NRC Staff's Response to the ACRS Interim Letter Regarding the AP1000 Design

Draft SER and Design-Basis Compliance

Figure 1: Uncertainty bands of aerosol removal rates (lambdas)

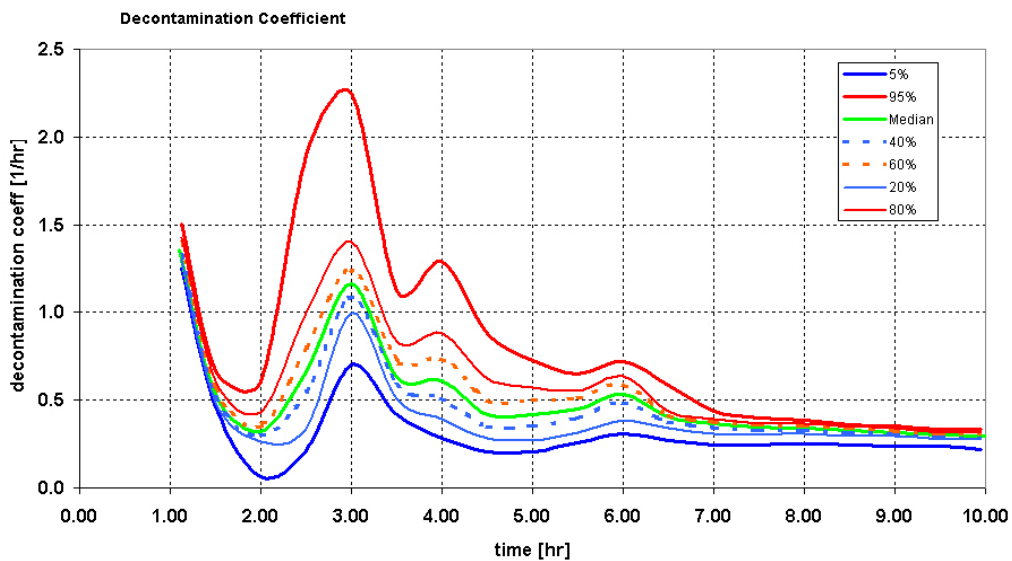
The ACRS and the staff have questioned the technical justification for the aerosol removal coefficient (λ) for containment. The issue has been addressed by Westinghouse using the STARNAUA code for the limiting sequence. We understand that the staff is using the MELCOR code to calculate the time dependence. We look forward to reviewing the staff's analysis.

The staff used an alternative thermal-hydraulic code (MELCOR), which includes the MAEROS aerosol mechanics code, as an input to a Monte Carlo sampling (200 runs) of 13 parameters known to affect aerosol settling and depletion. Engineering judgement was used for the choice of parameters, as well as for the range and distribution of their values, after several discussions between the staff and the contractor. The resultant distribution of possible aerosol removal coefficients has a 95-percent level of confidence, as depicted in Figure 1.

Although the Westinghouse calculated aerosol removal coefficient values lie within the staff's uncertainty analysis upper and lower bounds for portions of the early part of the accident, they generally do not lie below the median value calculated by the staff. While the staff does find that gravitational settling, thermophoresis and diffusiophoresis are physical processes that occur in the AP1000 containment and credit may be taken for aerosol removal through these processes, the staff is not approving the specific Westinghouse calculated aerosol removal coefficient values. These values are an intermediate product used in the dose analysis, and are not subject to any regulations.

The staff performed an independent dose analysis with the median aerosol removal coefficient values from the staff's uncertainty analysis, along with other analysis parameters and the bounding hypothetical atmospheric dispersion factors provided by Westinghouse, and the results are within the dose criteria of 10 CFR 50.34 and General Design Criterion (GDC)-19. The staff performed a sensitivity analysis which results in calculated doses that remain below the regulatory acceptance criteria for aerosol removal coefficients as low as those given in the 20th percentile in the staff's uncertainty analysis. Thus, while the staff and Westinghouse

diverge on values for the intermediate steps in the dose calculations, the staff agrees with the overall conclusion that the AP1000 design results in acceptable doses.
